The Sizewell C Project

9.120 Comments on Earlier Deadlines, Subsequent Written Submissions to ISH11-14 and Comments on Responses to Change Request 19 - Appendices - Part 2 of 4

Revision: 1.0
Applicable Regulation: Regulation 5(2)(q)
PINS Reference Number: EN010012

October 2021

DRAWING TITLE:
GREEN RAIL ROUTE
PROPOSED SECTIONS AND POTENTIAL
ALTERATIONS TO PROPOSALS

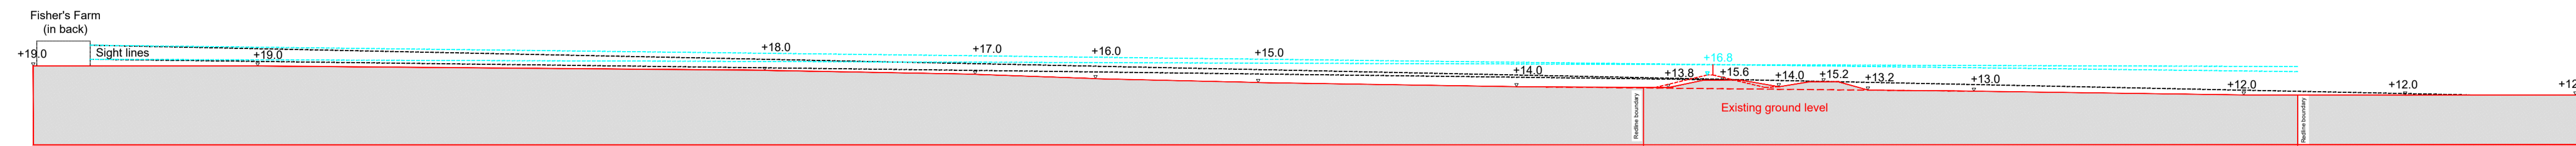
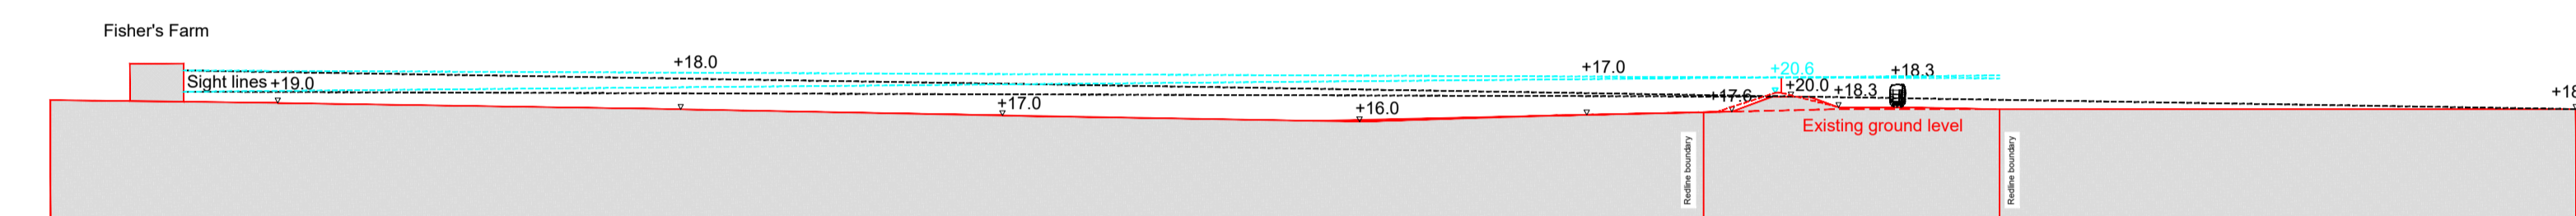
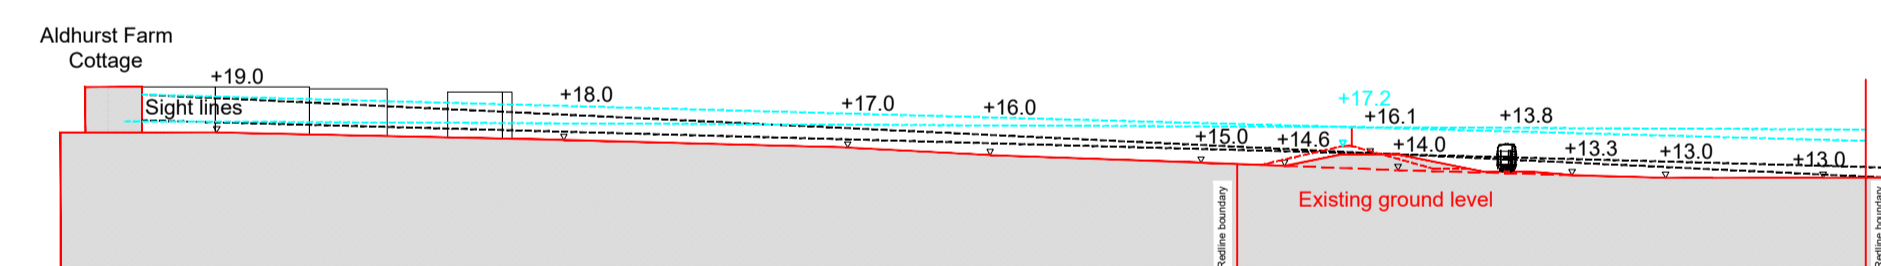
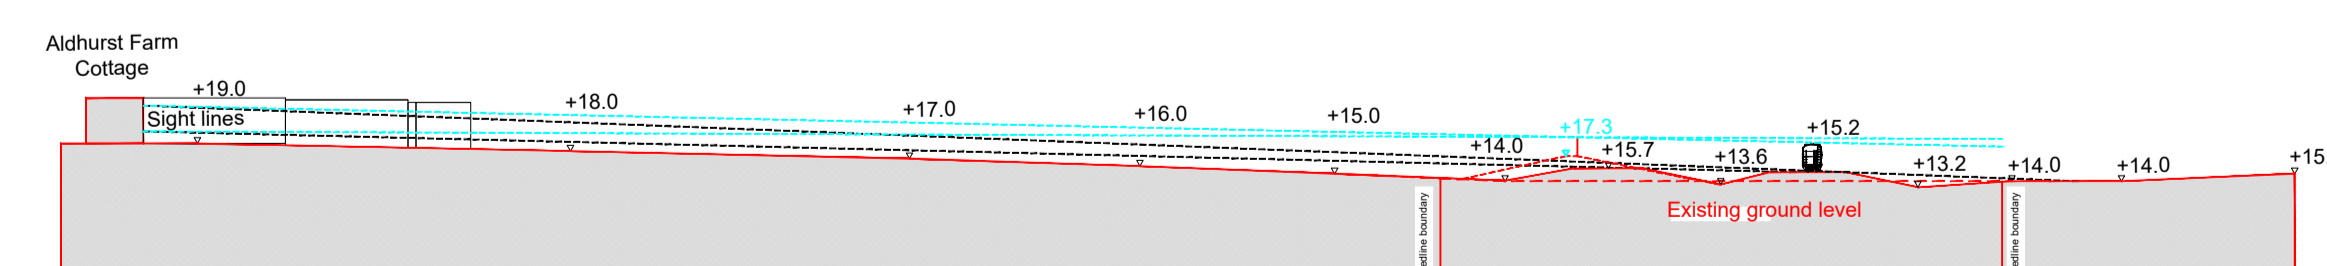
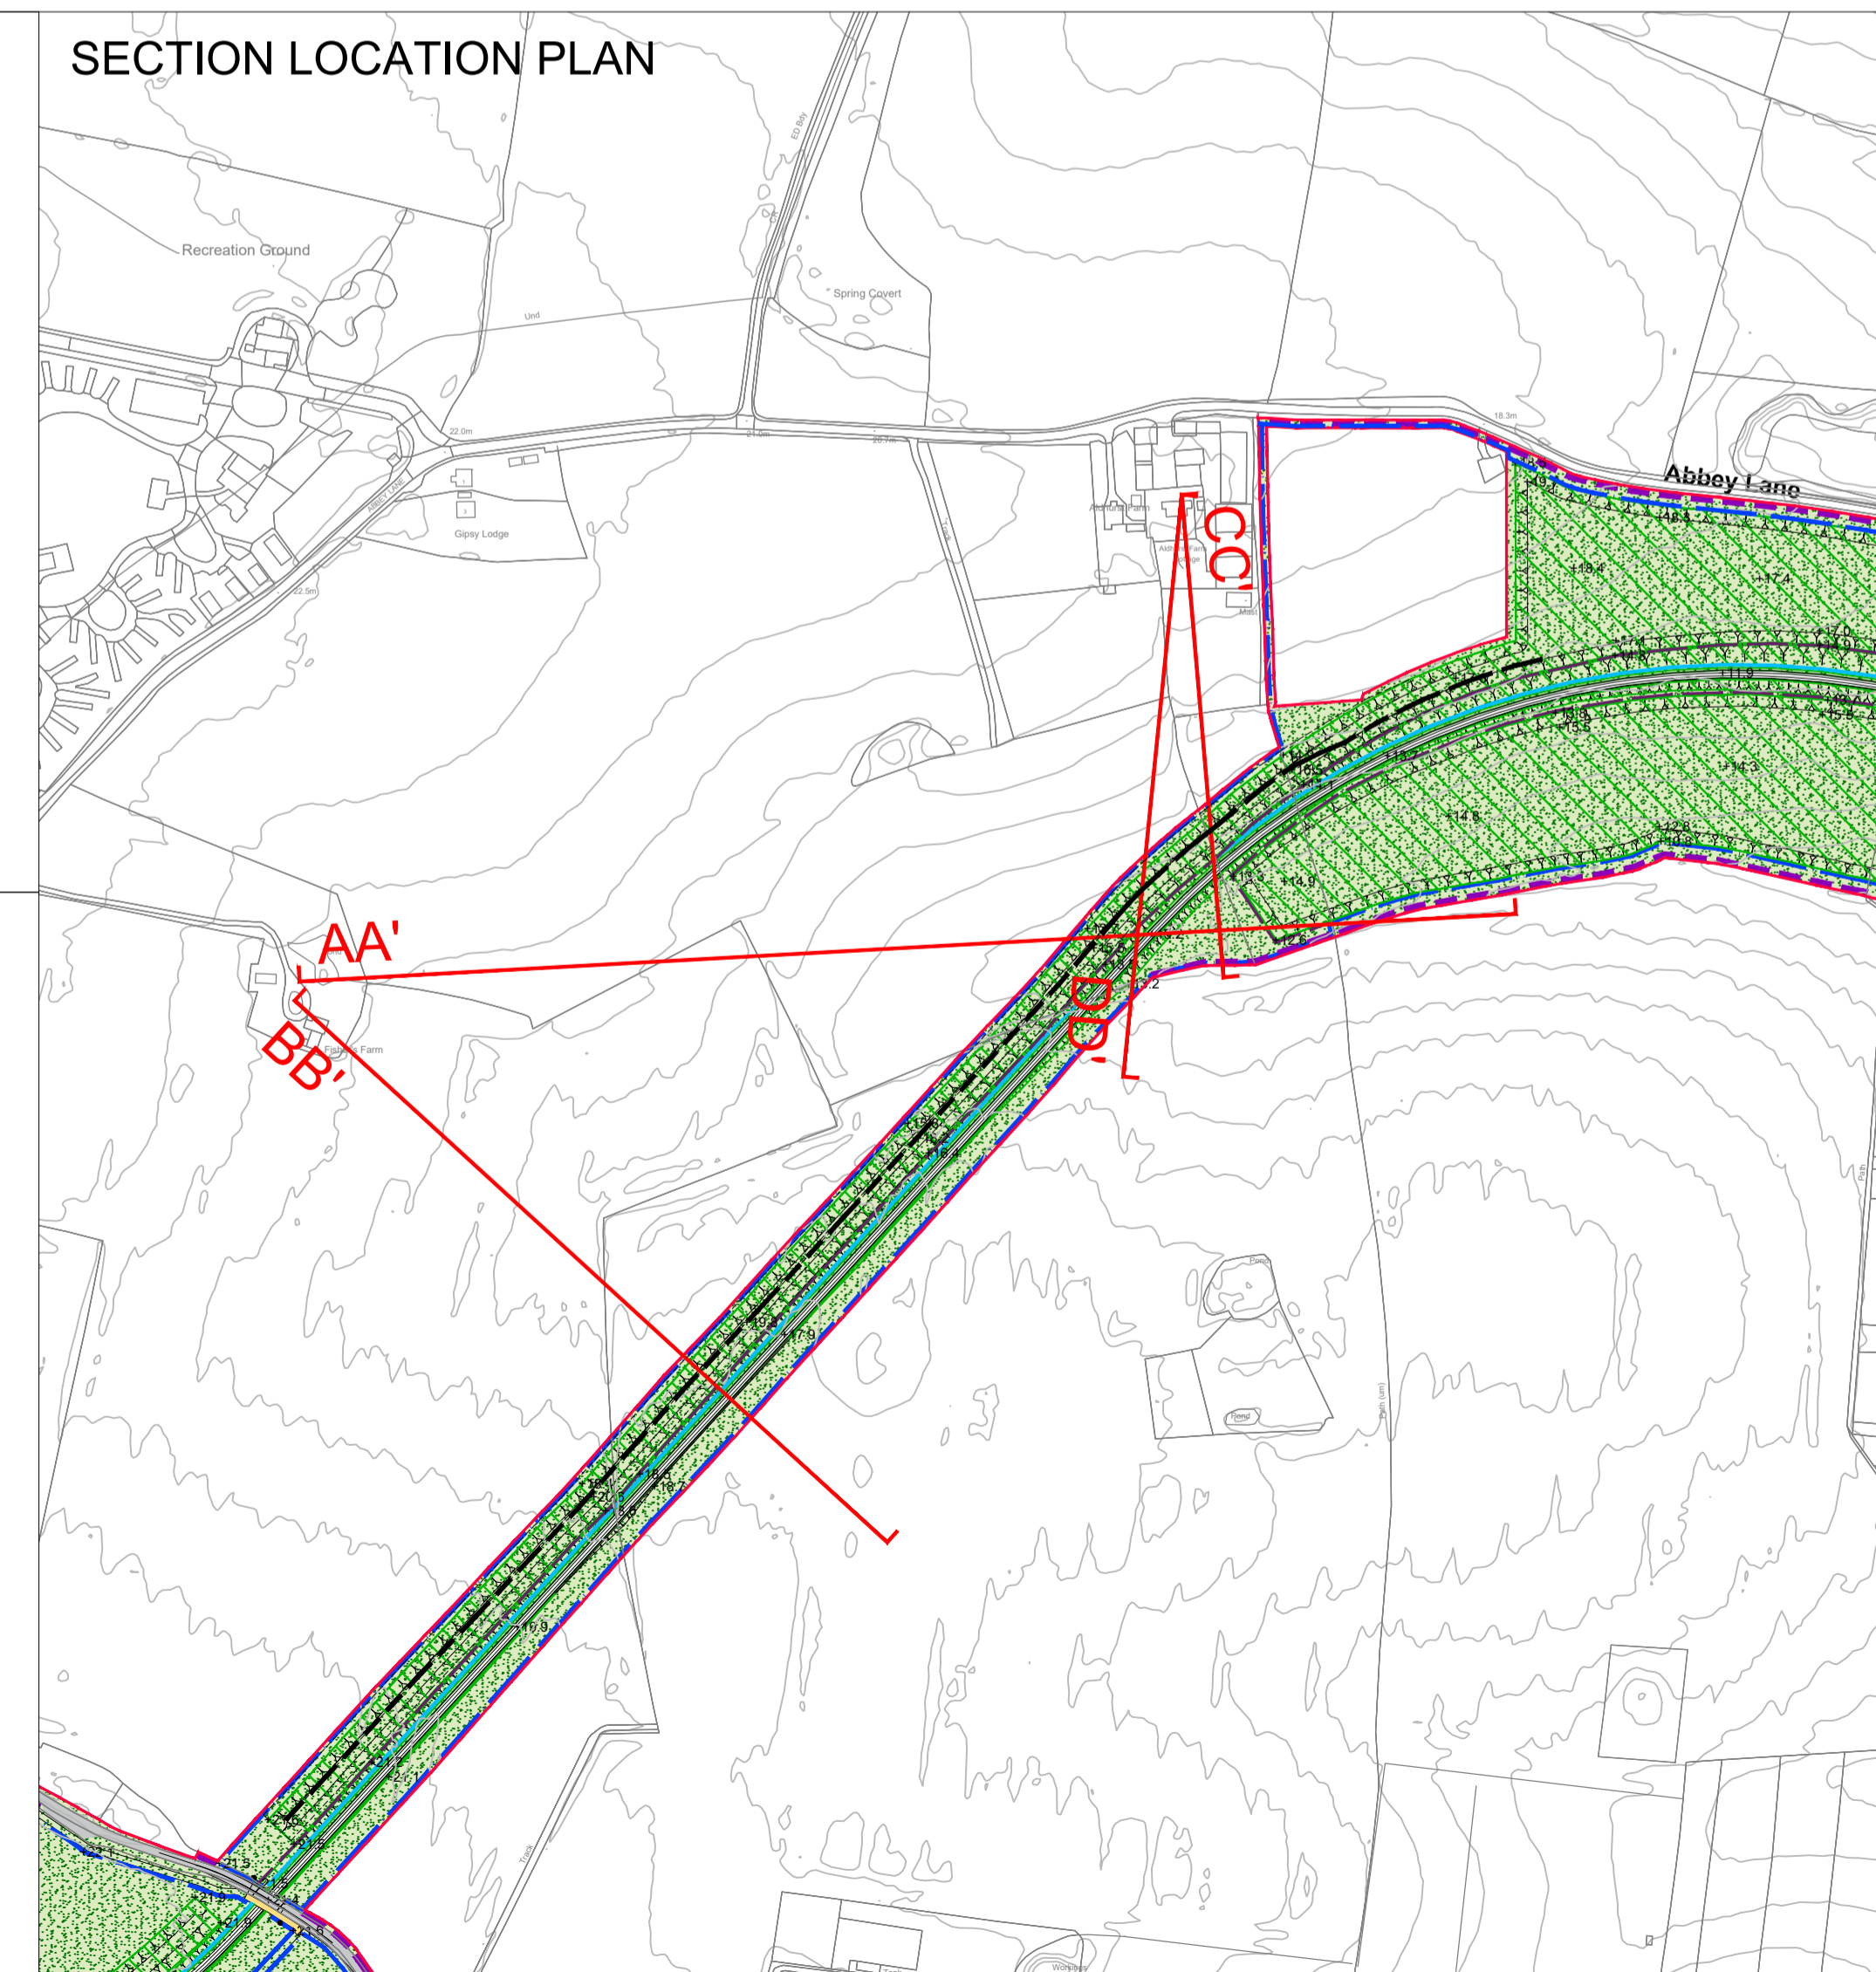
We have prepared amended plans for the route that explore the possibility of increased bunding to the east and the installation of acoustic fencing. We provide cross sections to further assist with understanding the performance of these two elements in relation to your property and the rail route at grade and on embankment.

The proposals comprise a bund up to 3m high with an acoustic fence up to 2.5m high which will screen views from your property (ground and first floor) towards trains on the rail track.

- EXISTING PROPOSALS ARE INDICATED ON THE SECTIONS BY SOLID LINES, WITH SIGHT LINES FROM FISHER'S FARM AND ALDHURST COTTAGES INDICATED WITH BLACK DASHED LINES.

- POTENTIAL AMENDMENTS TO THE CURRENT DCO SCHEME ARE INDICATED ON THE SECTIONS AS RED DASHED LINES FOR THE PROPOSED LANDFORM CHANGES, WITH THE POTENTIAL REVISED SIGHT LINES INDICATED BY BLUE DASHED LINES. THESE AMENDMENTS INCREASE THE HEIGHT OF THE PROPOSED BUND FROM APPROXIMATELY 2M TO APPROXIMATELY 3M, WITH A NOISE BARRIER OF APPROXIMATELY 2.5M IN HEIGHT INDICATED ON THE TOP OF THE BUND.

- ON THE SECTION LOCATION PLAN THE PROPOSED CHANGES IN PLAN FORM ARE INDICATED WITH BLACK DASHED LINES AND THE POTENTIAL 2.5M HIGH NOISE BARRIER IS SHOWN AS A WIDER BLACK DASHED LINE.
